## V2500-A1/A5/D5 SERIES PROPULSION SYSTEMS SERVICE BULLETIN

This document transmits the Revision 3 of Service Bulletin V2500-ENG-75-0051.

**V2500-ENG-75-0051**  
Transmittal - Page 1 of 1

AIR – ACTIVE CLEARANCE CONTROL (ACC) – REVISED CONNECTOR TUBE ASSEMBLY WITH NEW  
PERISEAL HOUSING CLAMPS

ACC Connector tube  
Fig.1 (Sheet 1)

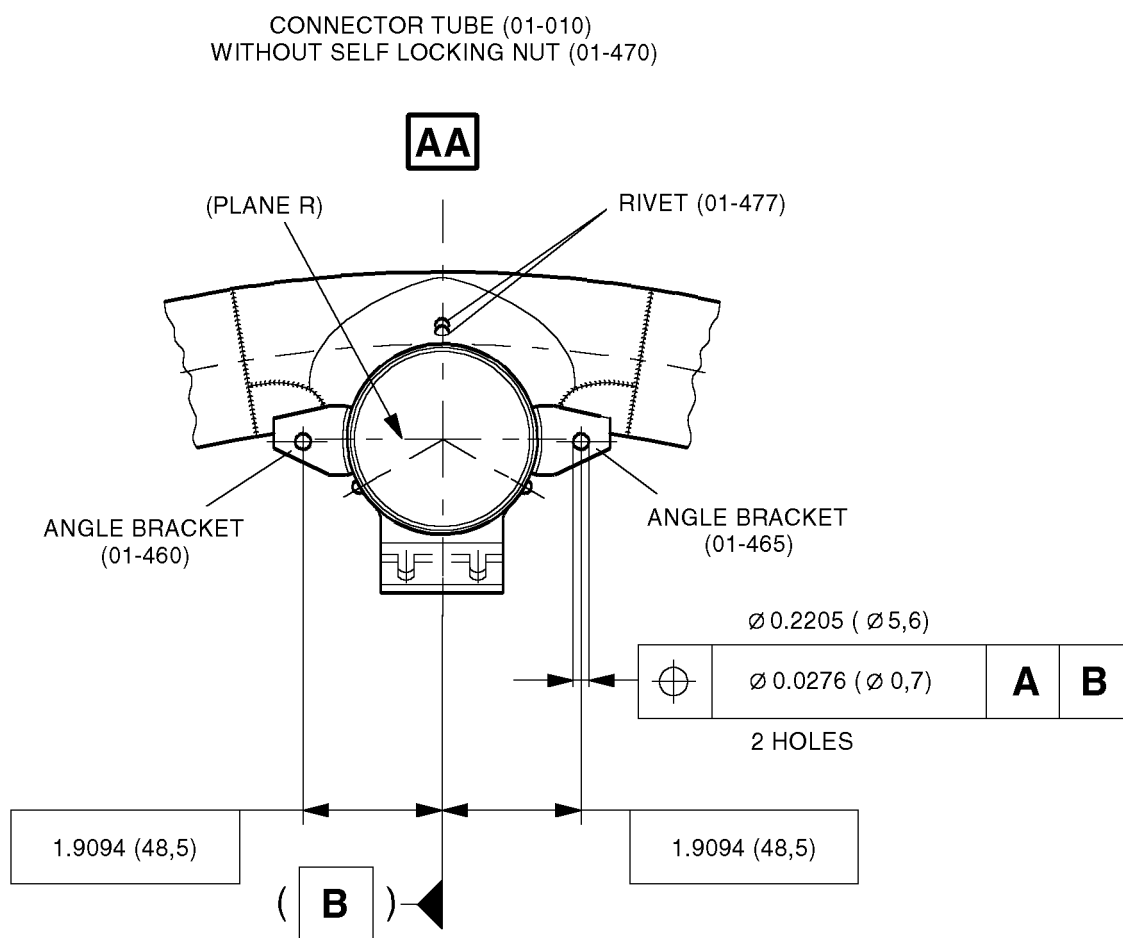
- (1) Install connector tube on a suitable work bench.
- (2) Carefully grind off the heads of the rivets . Refer to Fig 1, sheet 1.
- (3) Remove the clamps and the six rivets. Refer to Fig 1, sheet 1.

ACC Connector tube  
Fig.1 (Sheet 2)

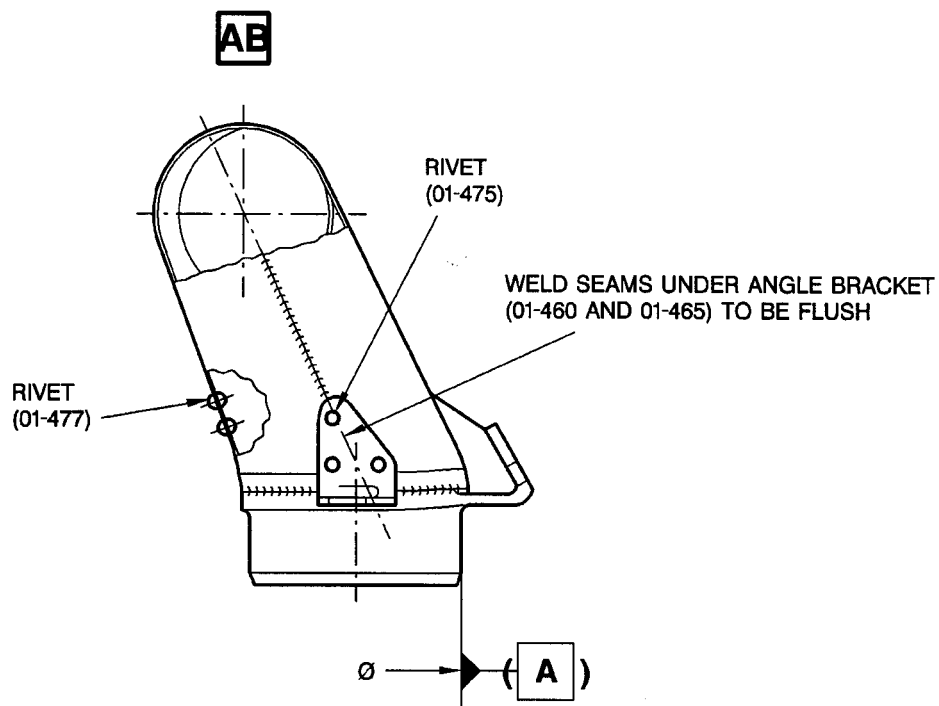
- R (a) Blank off the six existing rivet holes with blind rivets. Use  
R ST1086-01 or AN123168 replacement rivet. (Fig 1, sheet 2). Refer to  
R SPP TASK 70-39-03-390-501. Rivet holes must be tight.

- R (7) Drill initial rivet holes to oversize diameter 0.1275 to 0.1315 in. (3,24  
R to 3,34 mm)
- R (a) Blank off the six existing rivet holes with blind rivets. Use AN123184  
R or NAS1398C4-1 replacement rivet. (Fig 1, sheet 2). Refer to SPP TASK  
R 70-39-03-390-501. Rivet holes must be tight.

ACC Connector tube  
Fig.1 (Sheet 3)

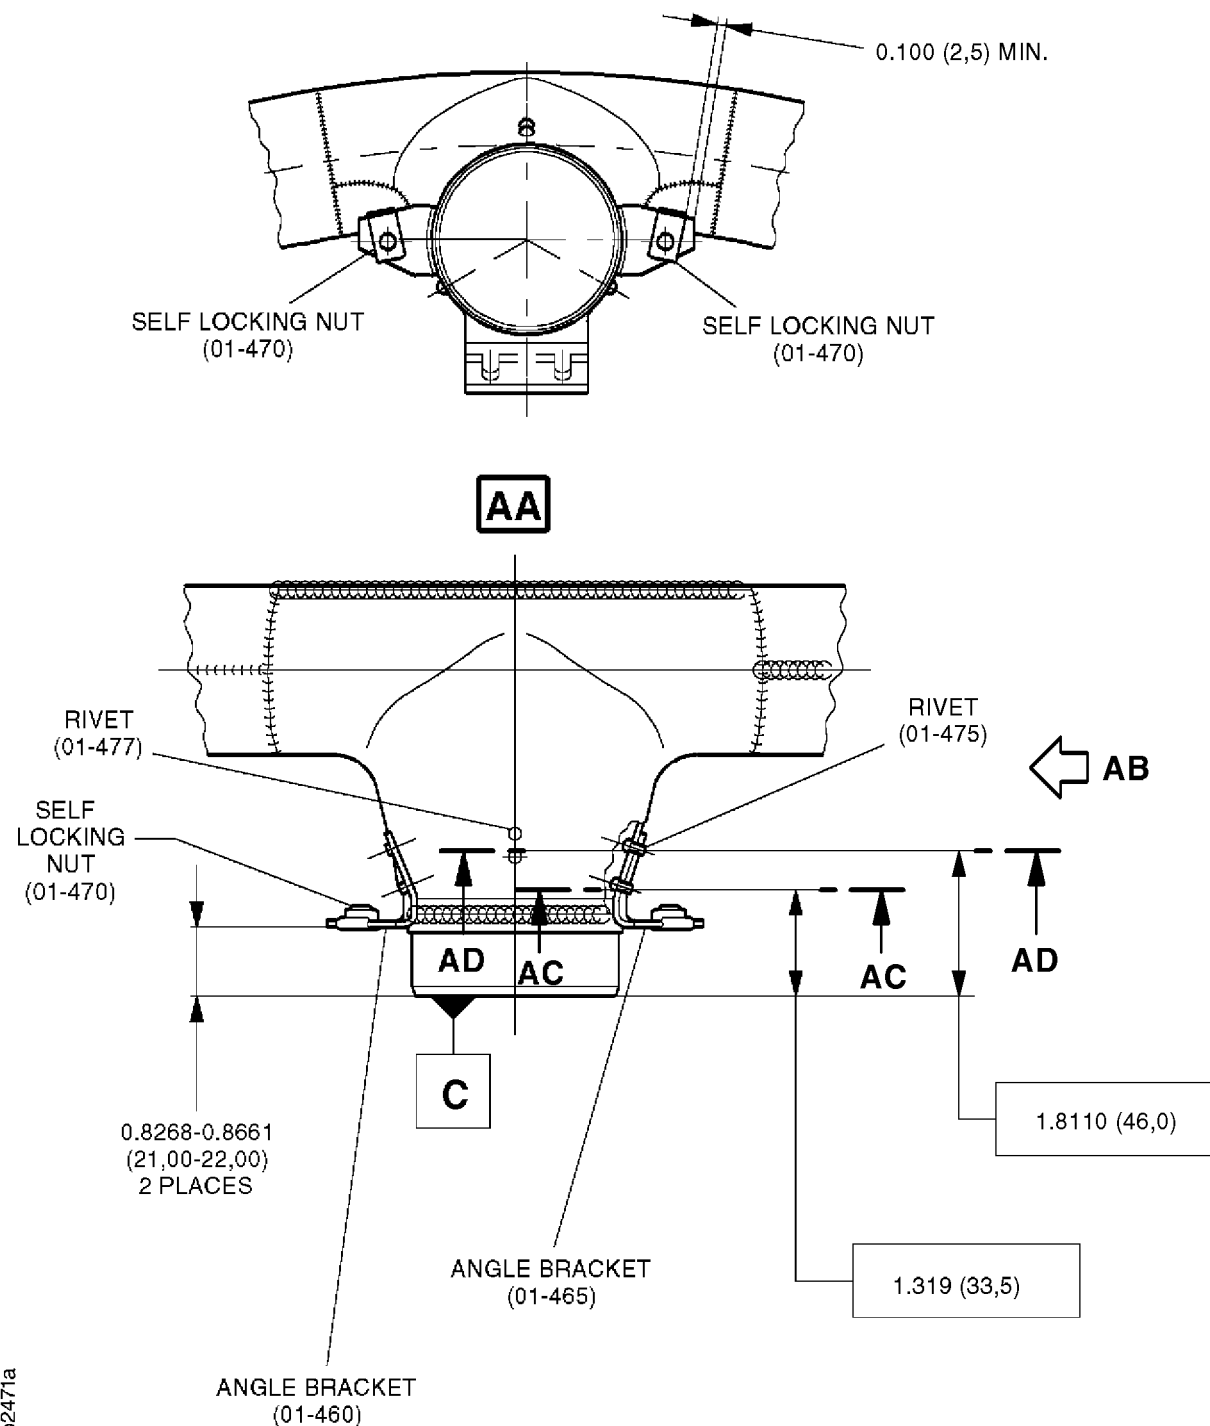
- R (9) Install angle brackets (Fig 1, sheet 3) (3A2317 and 3A2318). Use six blind  
R rivets (Fig 1, sheet 3) (ST1086-02) to attach the angle brackets. Refer to  
R SPP TASK 70-39-03-390-501.

ACC Connector tube  
Fig.1 (Sheet 4)

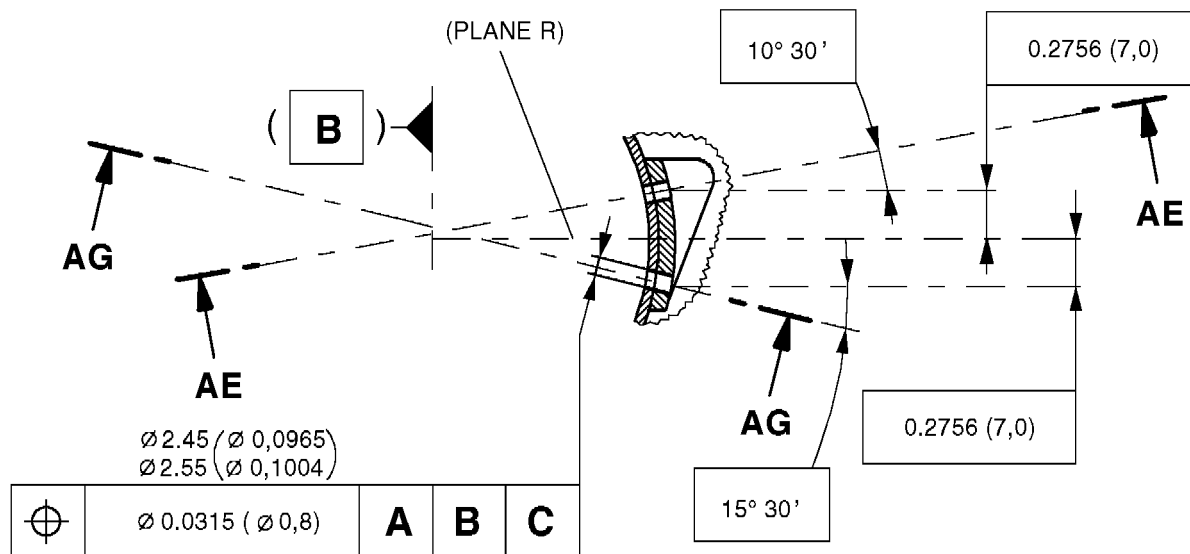
(11) Install clip nuts (4W0043) on to the angle brackets. Refer to Fig 1, sheet 4.
